Automotive Process Change Notification

PCN Reference: AU-14-168, D-Pak Leadframe and Bill of Materials (BOM)

Product Reference: Automotive Planar Gen5.x and 7.x MOSFETs in D-Pak packages, IR Mexico Assembly Site

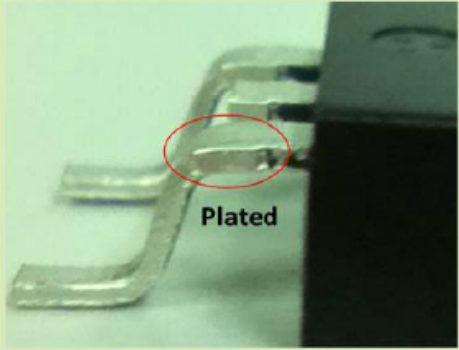
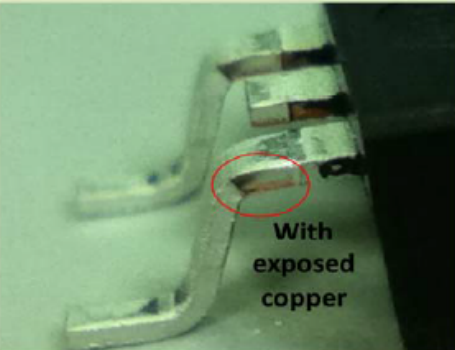
Parts manufactured with the new backend flow will show bare copper where the dambar was removed:

Current Process flow	Propose Process Flow	Differences
 <p>Plated</p>	 <p>With exposed copper</p>	<p>Exposed copper after dambar cut on Trim/Form/Singulation Integration. This condition is similar on lead cut and heatsink cut on the current process flow.</p>
